Ref: Removal/Variation of Conditions

Project: River Cottage, Church Street, Wargrave, Wokingham, RG10 8EP

Further to the Removal/Variation of Conditions drawings submitted as part of this application, please find below an explanation of the proposed alterations.

Changes - Ch-02, Ch-09, Ch-15 (Fenestration amendment)

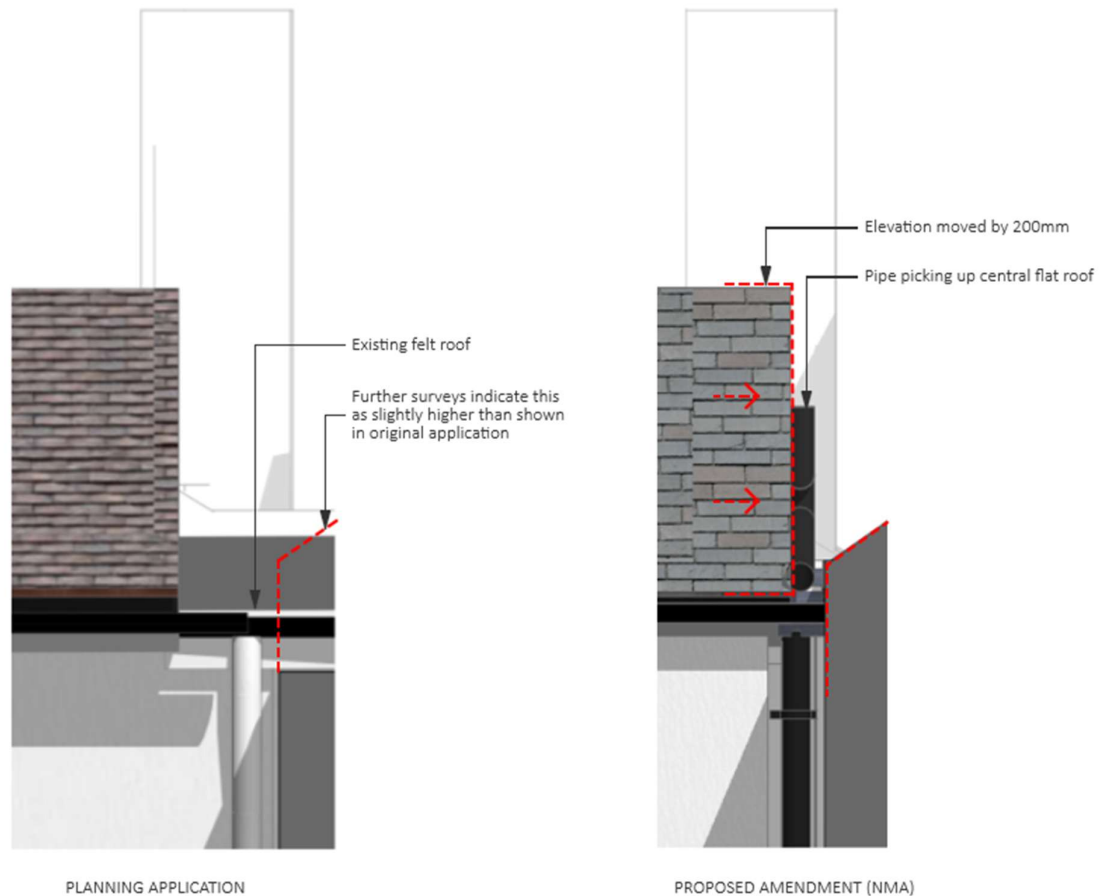
For change 02, the window has been relocated in response to internal layout adjustments and the revised position of the shower room. For change 09, we propose to change the existing single door to a double door arrangement of the same height and aspects. For change 15, we propose an additional roof light of the same proportions as the approved roof light.

Changes - Ch-05, Ch-06 and Ch-07 (clarity of detail):

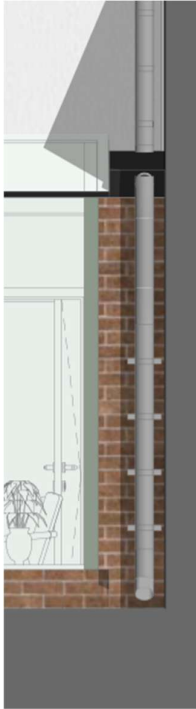
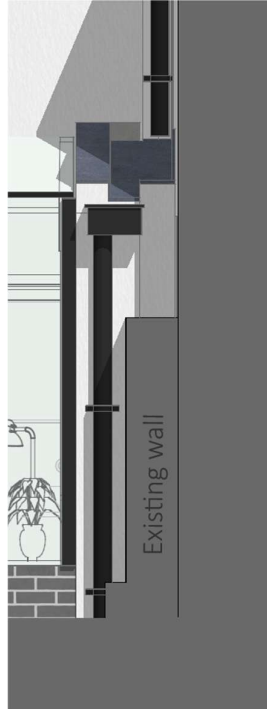
We propose to adjust the wall to a rendered finish and introduce a parapet for the glass roof to abut.

Changes - Ch-08 (clarity of detail)

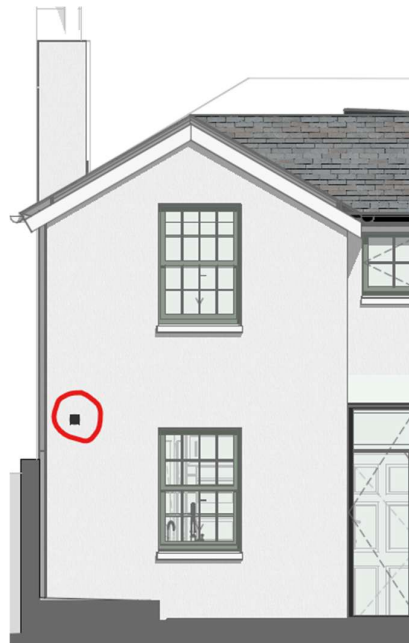
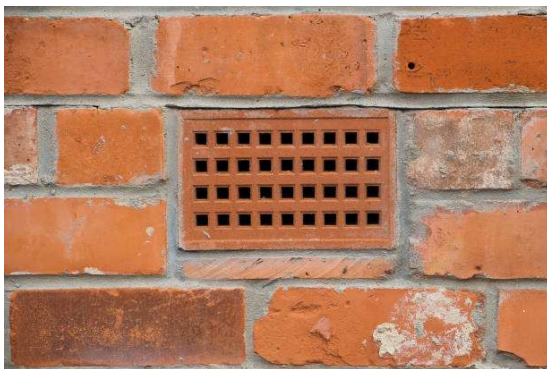
There is an existing extractor located to the rear of the gable end. We proposed to retain the location of this extractor vent in the new double storey extension but change it from a modern vent to a terracotta brick vent which will be painted white to match the colour of the proposed render.

(Existing extraction vent highlighted in red)

(Proposed extraction vent indicated in red)

(Proposed terracota brick vent to be painted white in keeping with render colour)

Changes - Ch-10, Ch-11, Ch-16 (structural design)

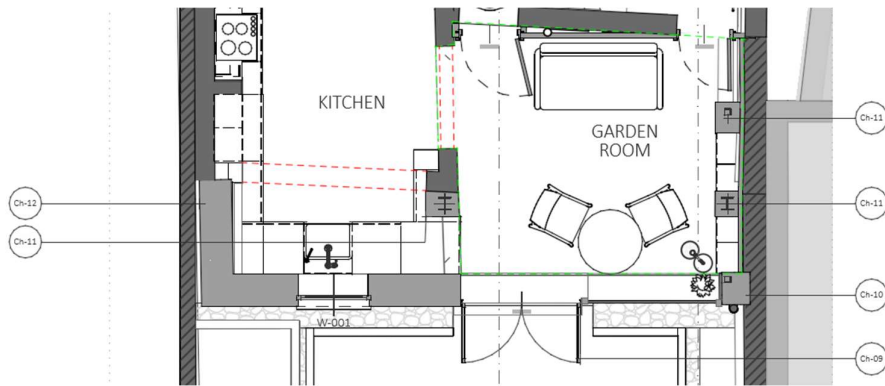
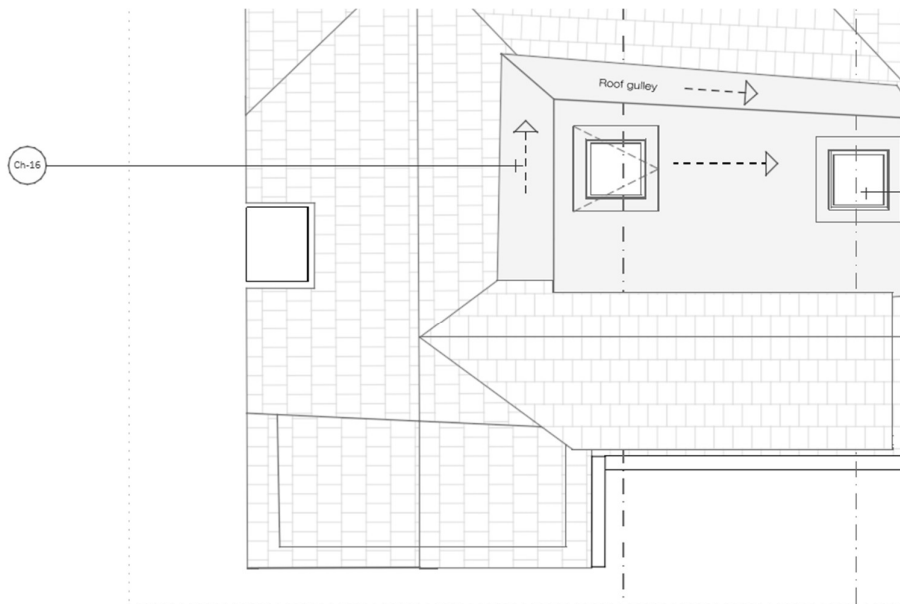
A structural design has now been completed, resulting at ground floor level the introduction of internal structural columns in leu of the proposed new internal wall shown on the original planning application. These allow the rear single-storey and double-storey extensions to be constructed with minimal impact on the existing walls.

The proposed rear flat roof abutting the existing rear gable has been reduced in size to reduce the load is carried by the existing elements:

Changes - Ch-12, Ch-13 (Abutment detail)

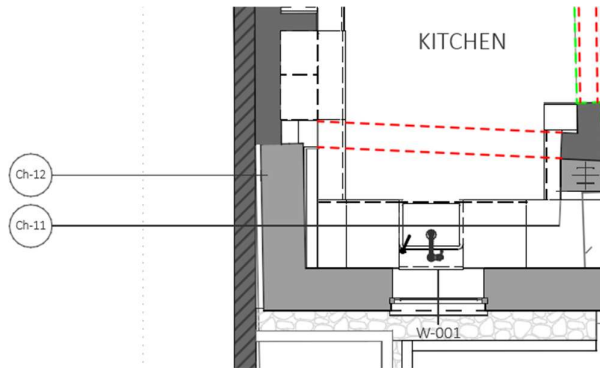
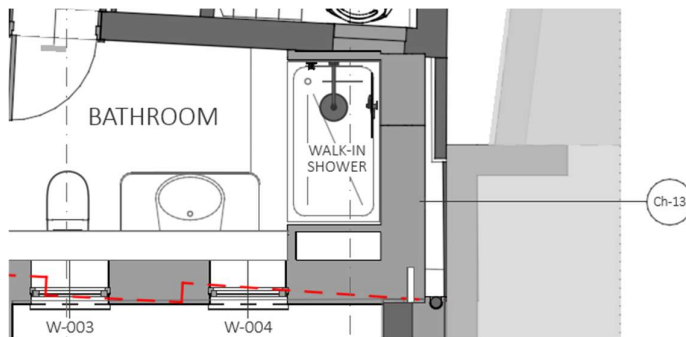
To the double-storey extension, the side abutting the existing garden wall to be set back slightly to allow for the undulation in the existing walls and it is at a slight slant.

To the rear of the new (replacement) extension, at high level, we are proposing to construct a new independent side elevation wall, rather than installing a new insulated lining against the party wall belonging to Sister's Cottage.
